Subject: **Request for Modification to the Individual Section 404 Permit, Section 401 Water Quality Certification and Neuse Riparian Buffer Authorization** for the construction of the US 70 Bypass from east of SR 1556 (Wayne Memorial Drive) to east of SR 1323 (Promise Land Road) in Wayne and Lenoir Counties. State Project No. 34461.3.8. TIP No. R-2554BB&C.

The North Carolina Department of Transportation (NCDOT) requests a modification to the existing Individual Section 404 Permit, Section 401 Water Quality Certification and Neuse Riparian Buffer Authorization for the R-2554 BB and C project. This modification is being requested due to clarifications or revisions needed on the previous modifications dated December 27, 2012 and January 29, 2013, a study area change between the planning phase and final design, and a topographic error on plan sheets 47 and 47A. Enclosed with this request are updated permit drawings, an updated impact summary sheet, and updated borrow site mapping.

**R-2554BB&C
WETLAND SITE MAP
REVISED: 05-17-2013**

PERMIT DRAWINGS
 SHEET 135^B OF 135

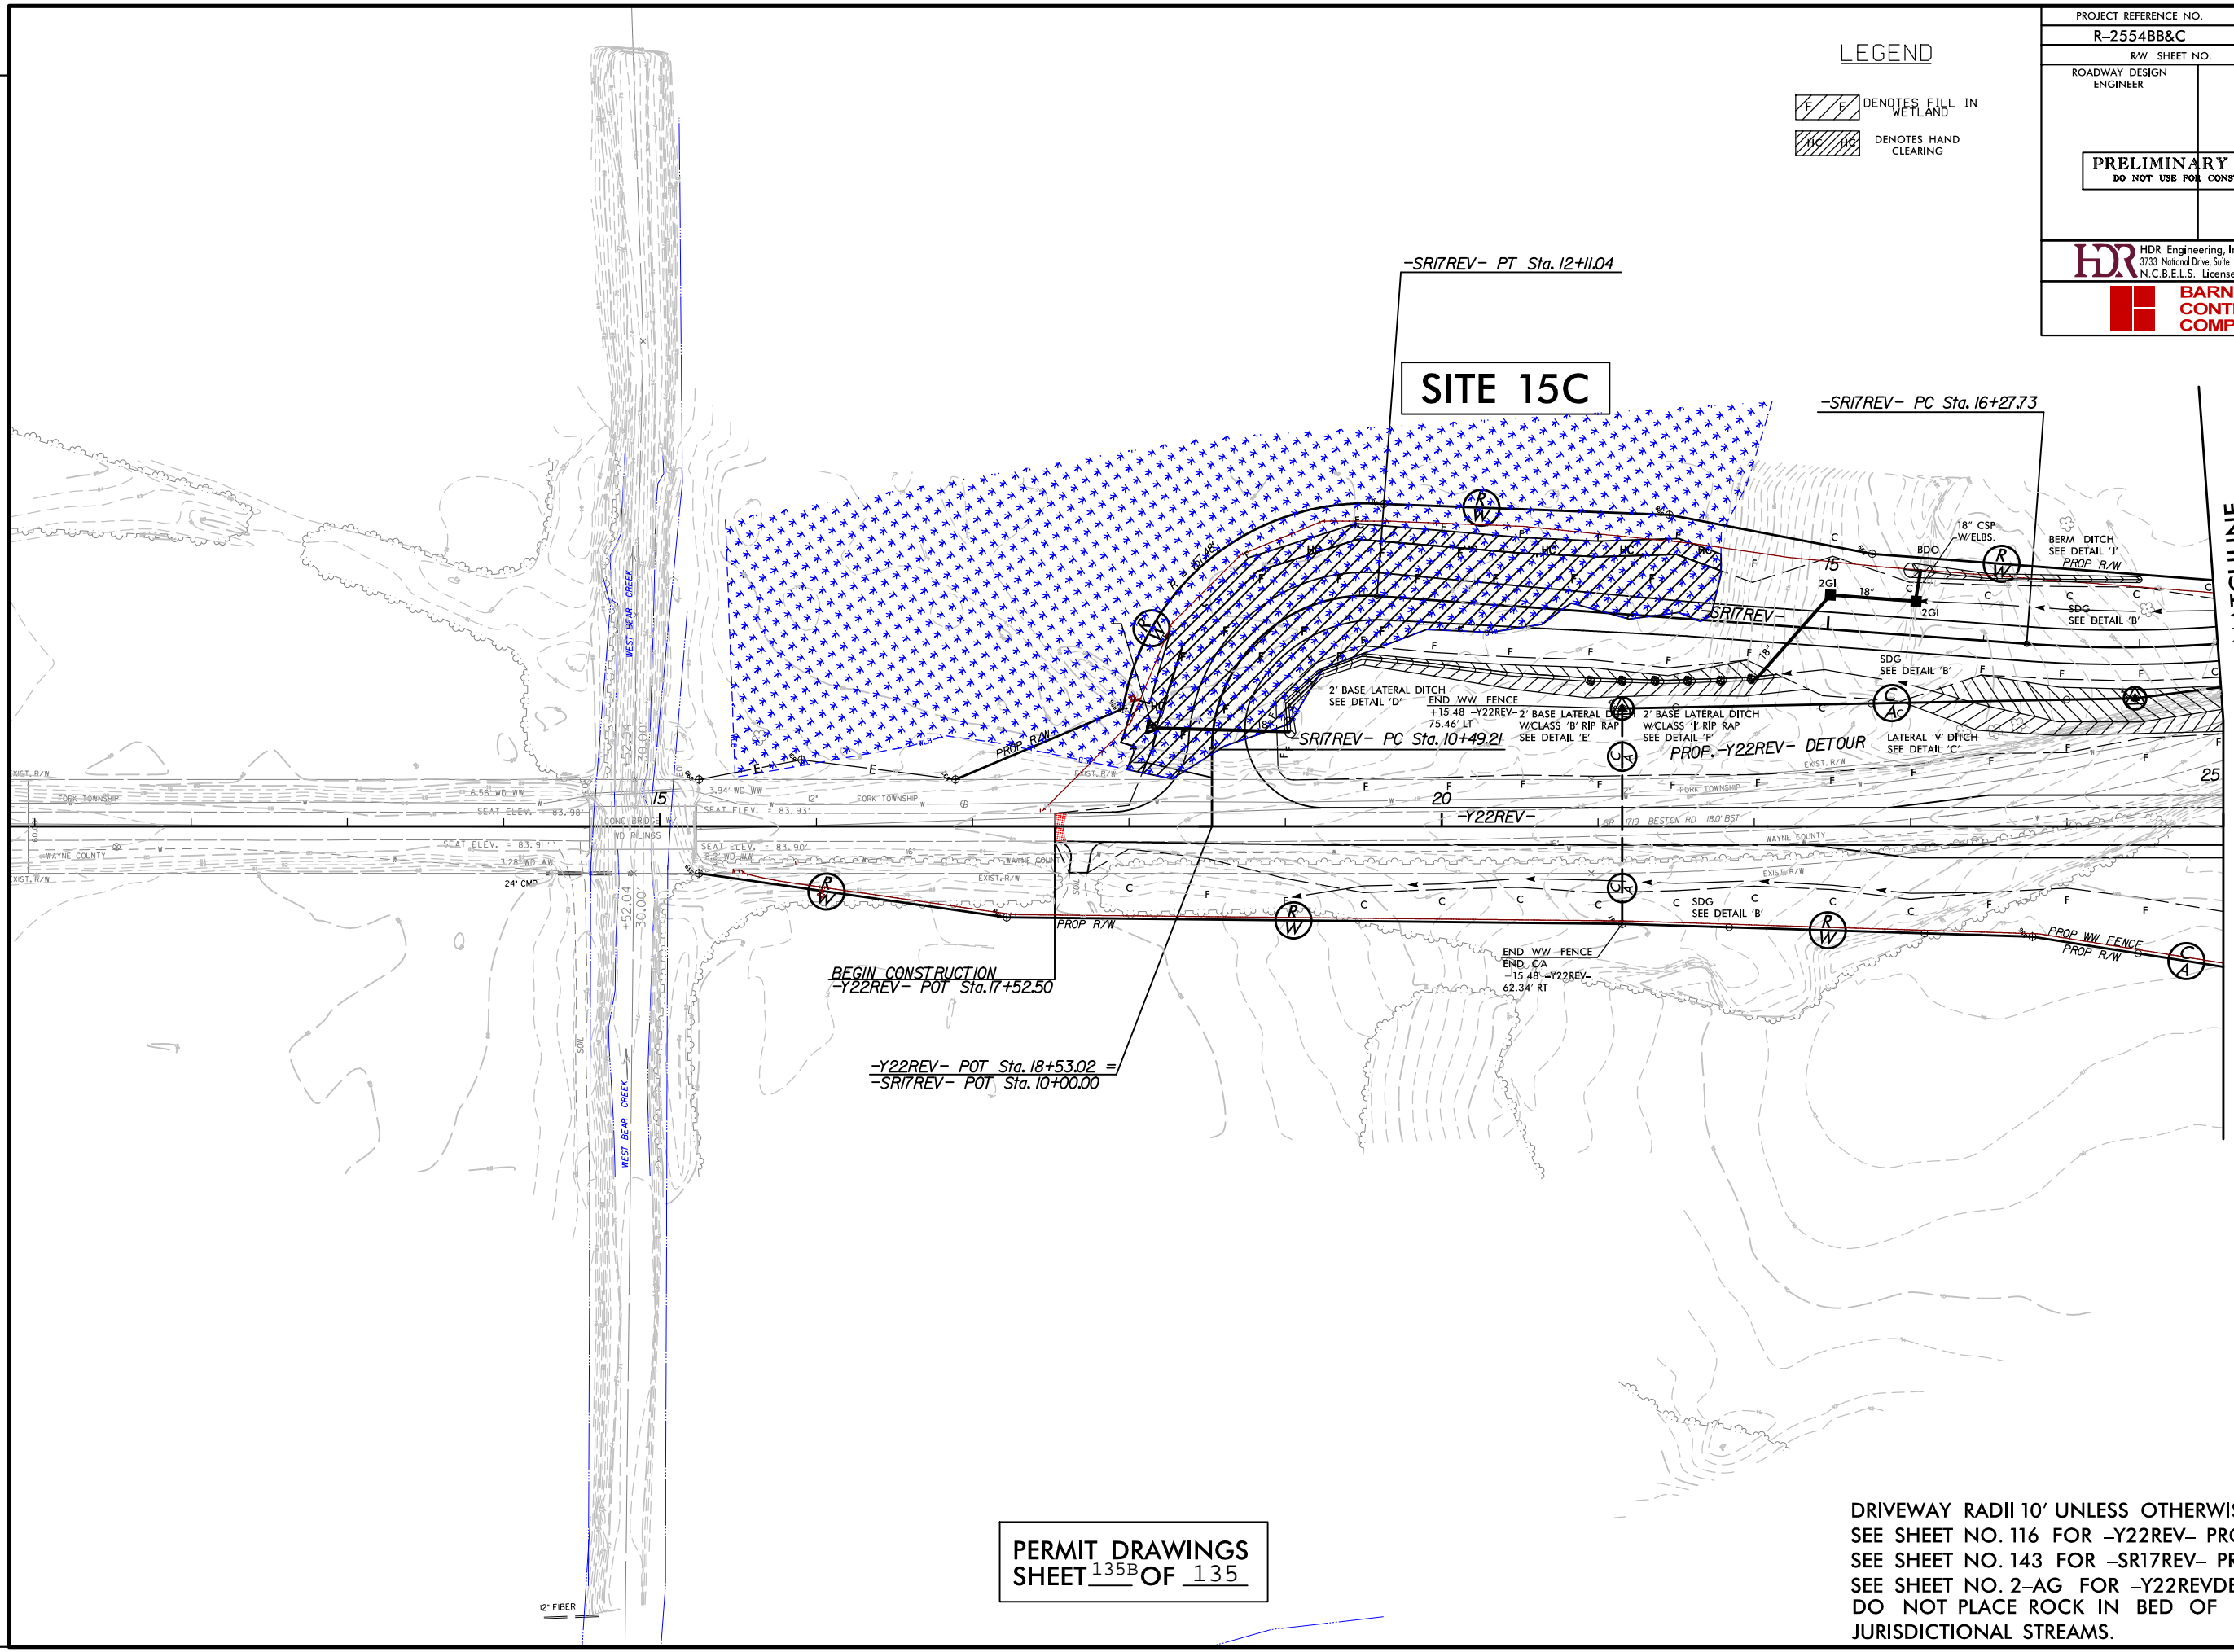
A jurisdictional wetland located at approximately Sta. 10+30 to 14+30 along SR17REV (Beston Road) was inadvertently omitted due to the change in study area. This area was not included in the Natural Resources Technical Report or wetland file initially used to create the plan sheets for the project as it was outside the study area. This wetland was discovered during permitted waterline relocations which are independent of the R-2554 project. The impacts for the service road which is within this additional study area, include 0.50 acre of fill in wetlands. Additionally there will be 0.11 acre of hand clearing in an area that was previously impacted by the utility relocations. This new area is being referred to on the permit drawings and summary impact table as Site 15C.
